OFFICE-FITOUT-01 · Level 6 tenant floor (synthetic) · issue 6: Rev P4 · 2026-10-12 · For approval · A3 1:100 reissue: director’s office kept, reception moved; held-seat assessment

OFFICE-FITOUT-01 · Level 6 tenant floor (synthetic)

L1 · OFFICE-FITOUT-01 · Level 6 tenant floor (synthetic) — floor plan

OFP-101 Rev P4

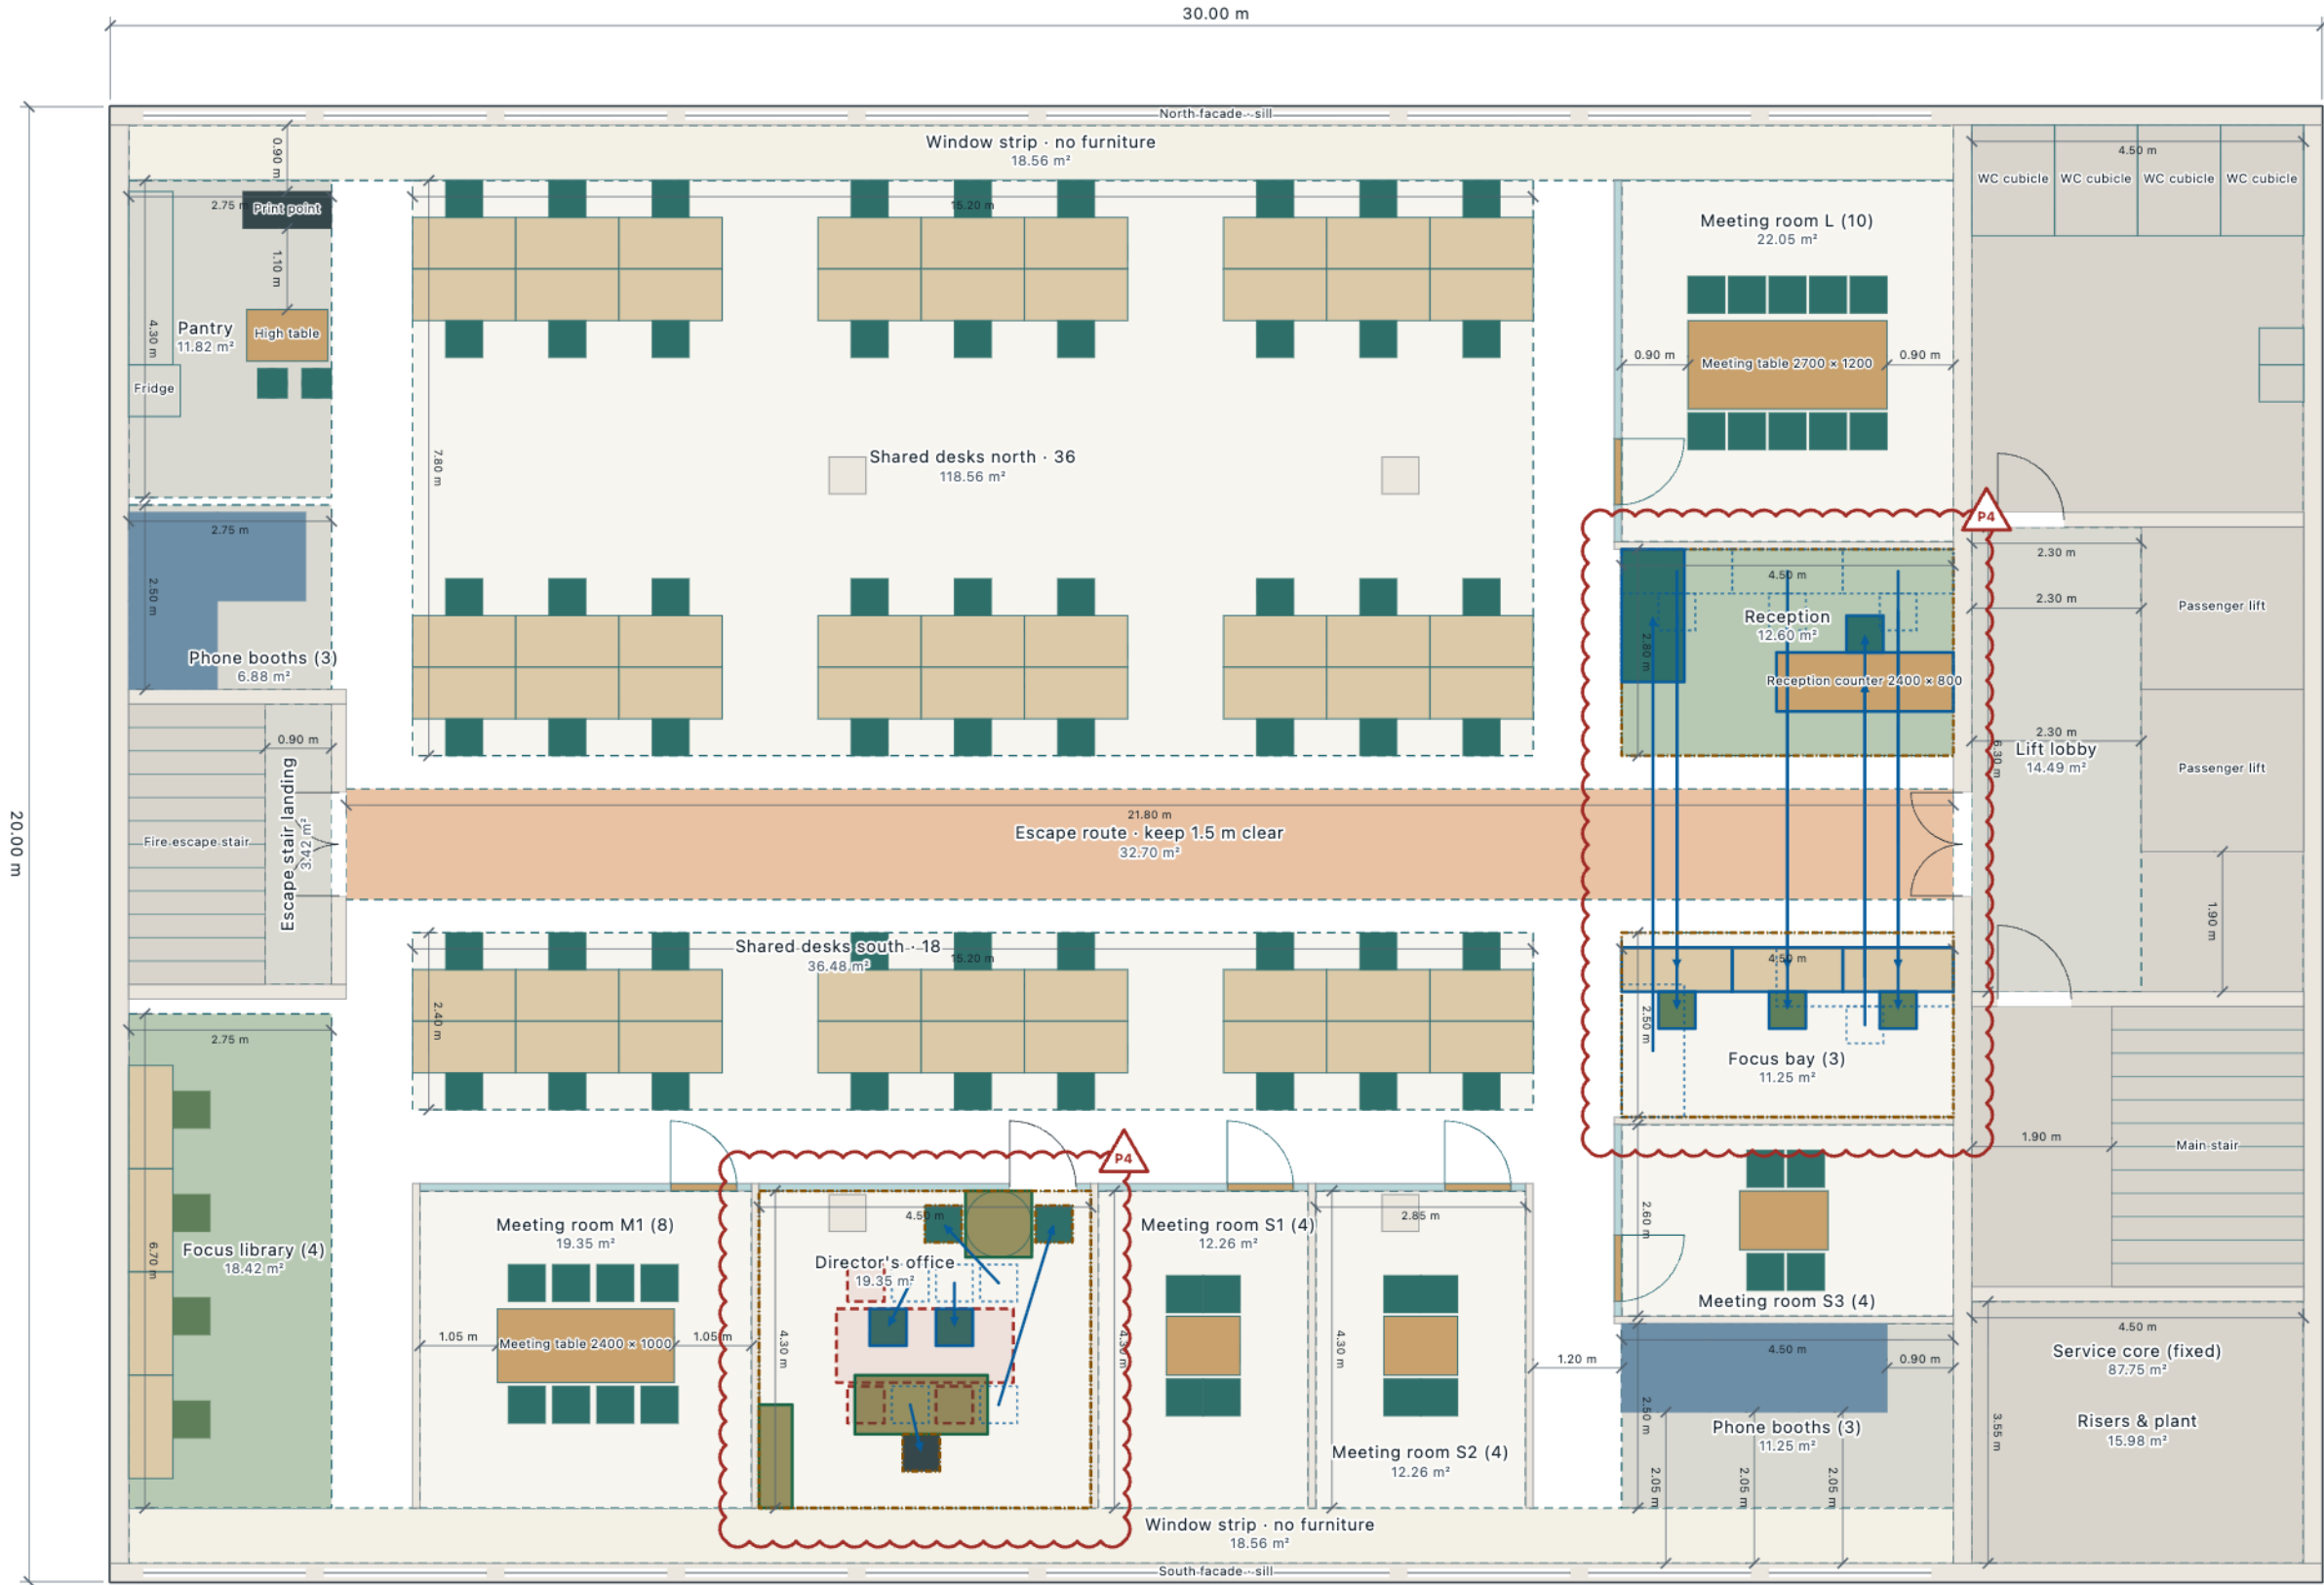
Differences Rev P3 → Rev P4 · plan: Rev P4; dashed: parts of Rev P3 where they stood

Removed 4 Added 3 Moved 14 (arrow: old → new) Changed 6 Rev P4 clouds 2: changed since the previous issue
